Status Purpose of Issue  
 S2 For Information

project  
**Asset Management Facility (AMF)  
 Samlesbury**

drawing title  
**Comparative Site Plan**

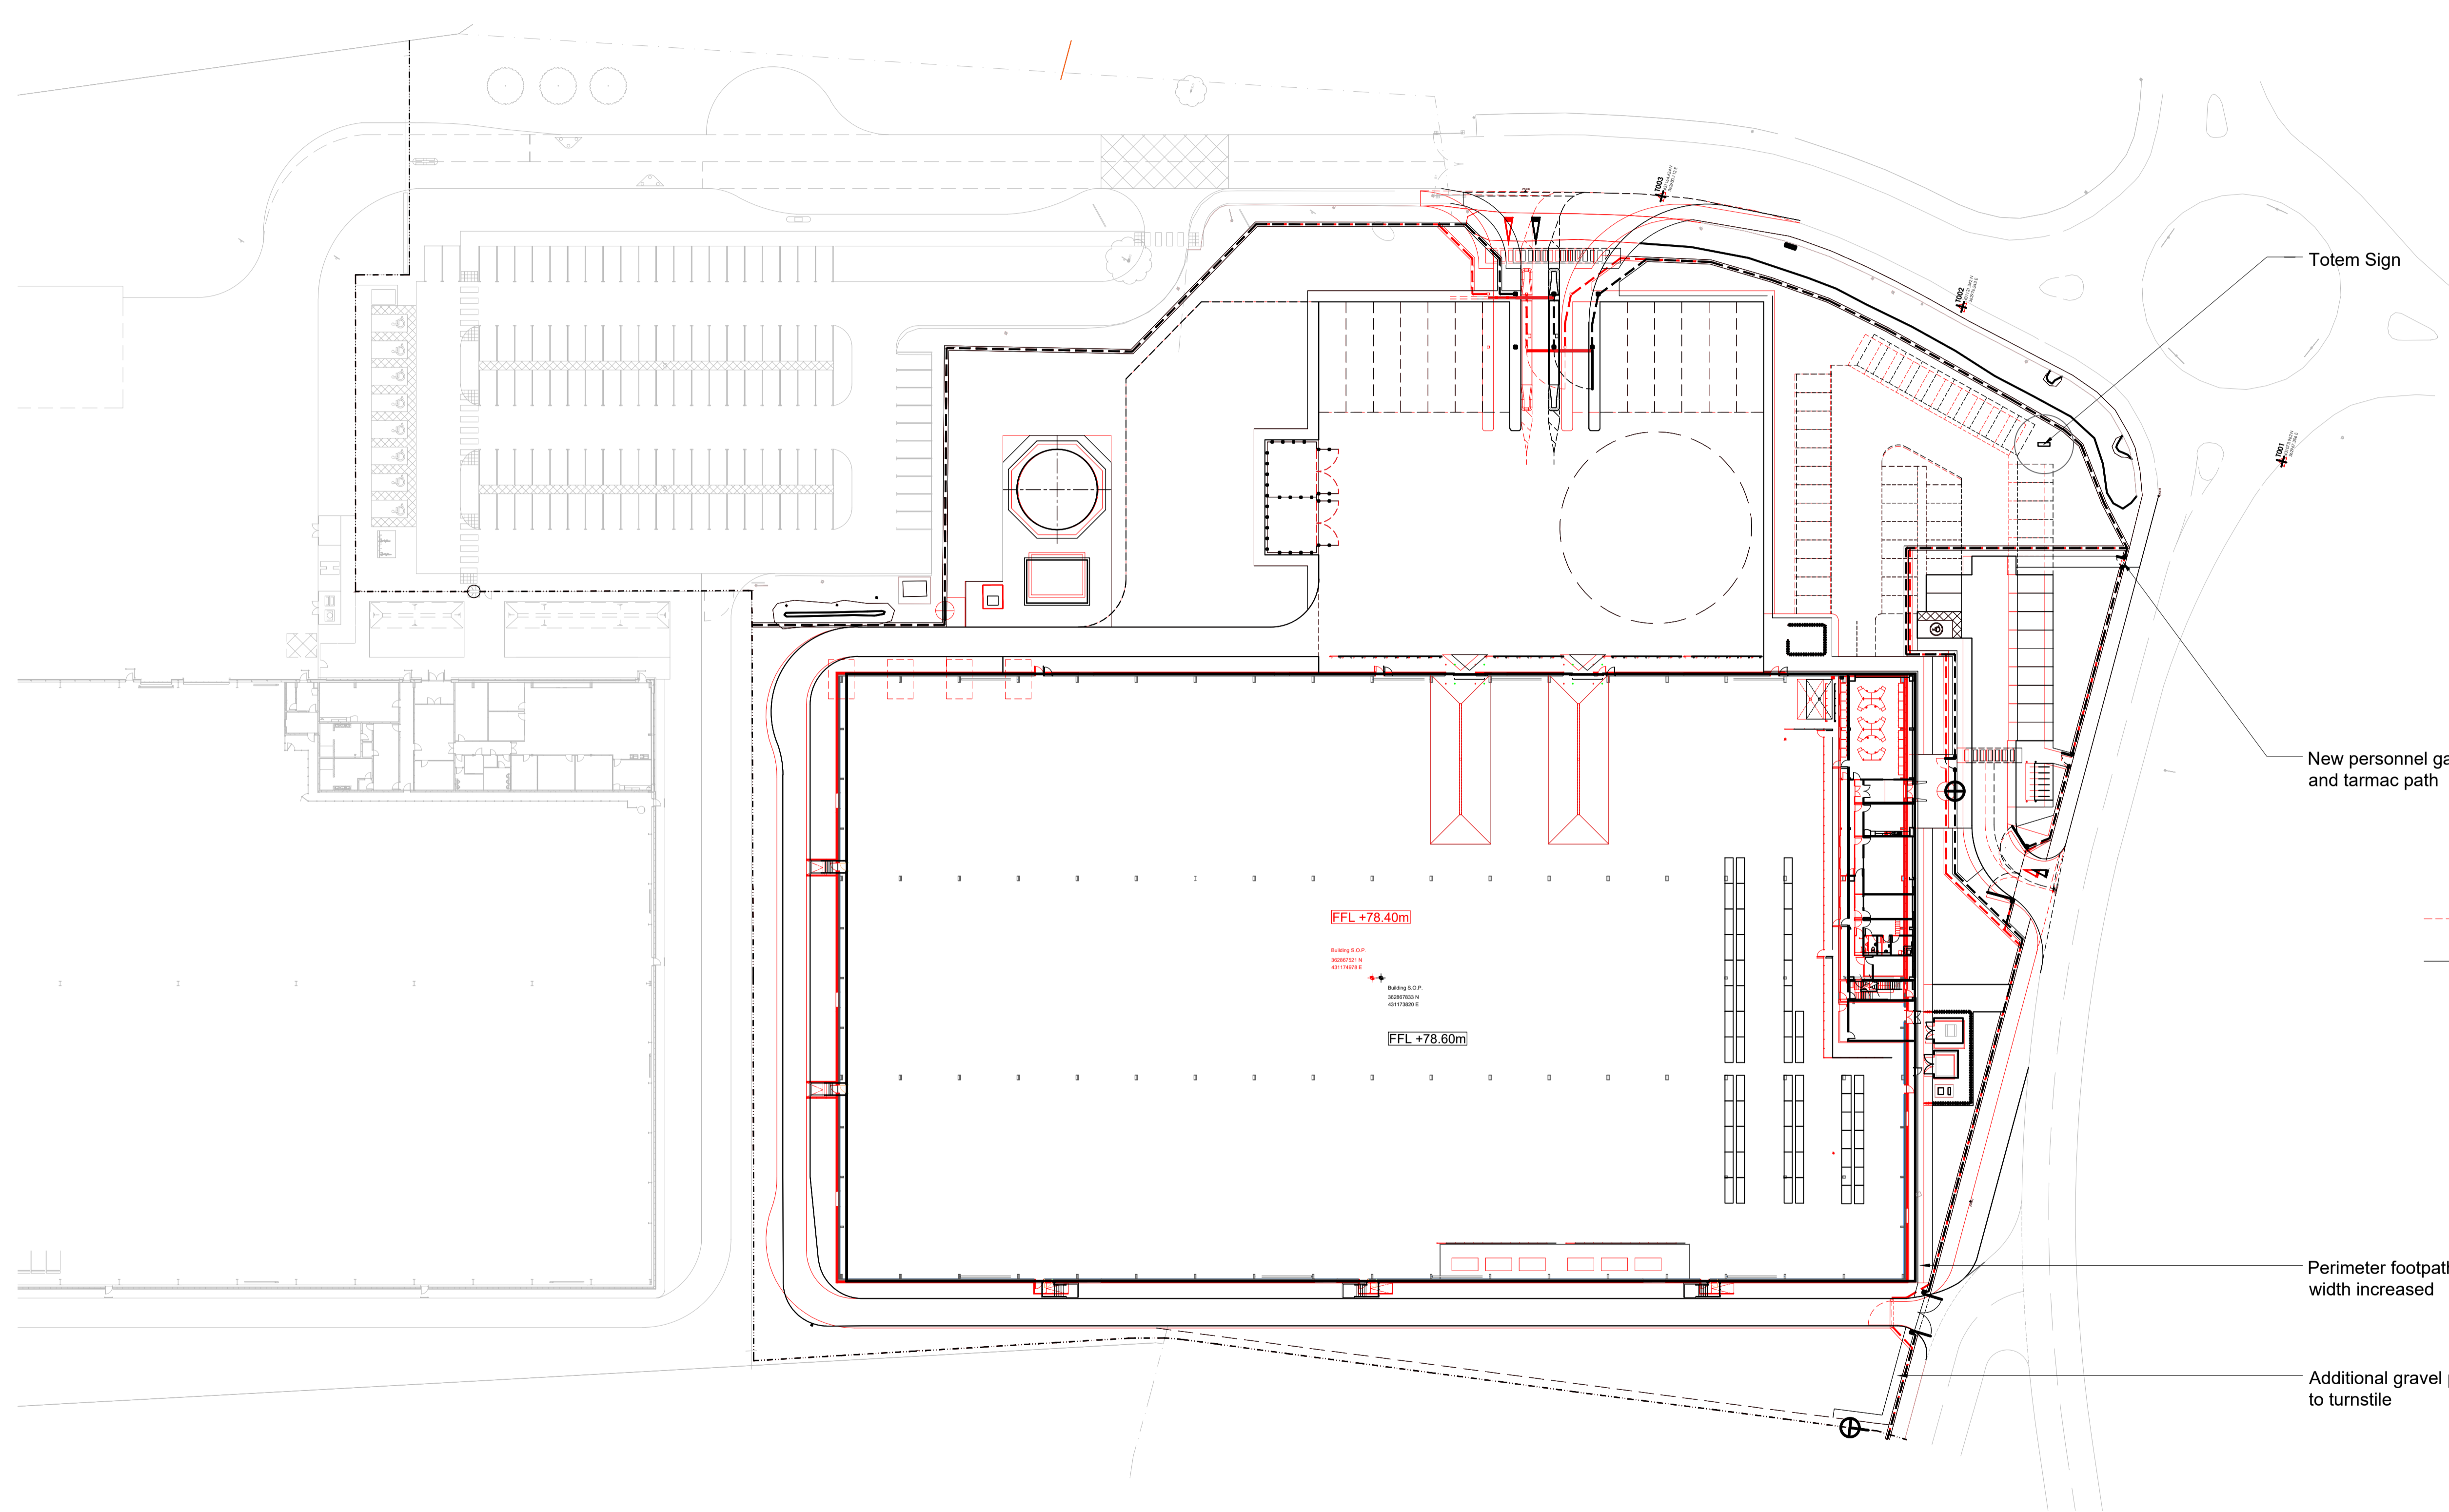
Totem Sign

New personnel gate and tarmac path

Perimeter footpath width increased

Additional gravel path to turnstile

----- Planning Approved Layout  
 \_\_\_\_\_ Current Layout

P5	16/07/20	NC	RD
Crossing removed as instructed by client			
P4	07/07/20	NC	RD
Entrance to Fire Track road revised to suit site levels			
P3	27/05/20	NC	RD
Totem Sign added and noted			
P2	15/05/20	DJS	RD
Second Issue			
P1	15/10/19	NC	RD
First Issue
